BLAENAU GWENT COUNTY BC	DROUGH COUNCIL
--------------------------------	----------------

Report to	The Chair and Members of Planning, Regulatory and General Licensing
Report Subject	Planning Applications Report
Report Author	Team Manager Development Management
Report Date	26 th October 2021
Directorate	Regeneration & Community Services
Date of meeting	4 th November 2021

Application C/2021/0209 No:	App Type: Full	
Applicant:	Agent:	
Mr Liam Jenkins	George and Co	
53, Larch Lane	Mr Steven George	
Bedwellty Gardens	1st Floor Woodfired Studios	
Tredegar	62 High Street,	
NP22 4FA	Merthyr Tydfil	
	United Kingdom	
	CF47 8DE	
Site Address:		
53 Larch Lane, Bedwellty Gardens, Tredegar		
Development:		
Proposed two storey rear extension.		
Case Officer: Jane Engel

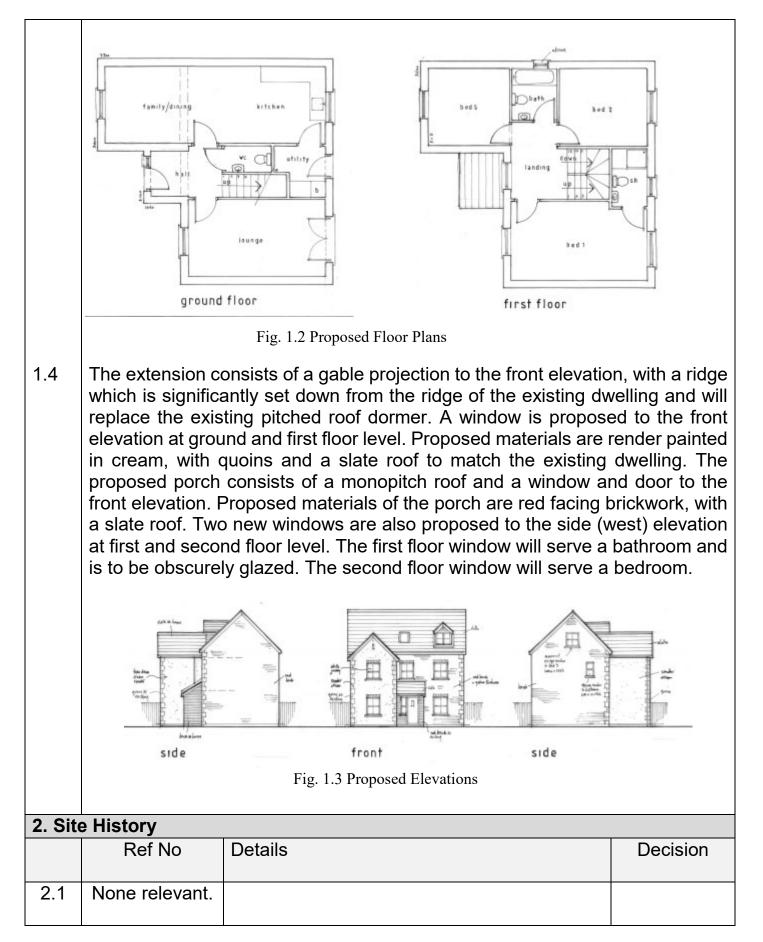
1.3 Planning permission is being sought for the erection of a double storey extension and porch to be sited to the front of the existing dwelling. The proposed extension will be used as a family/dining room at ground floor level and a bedroom at first floor level measuring approximately 3.6 metres in depth.
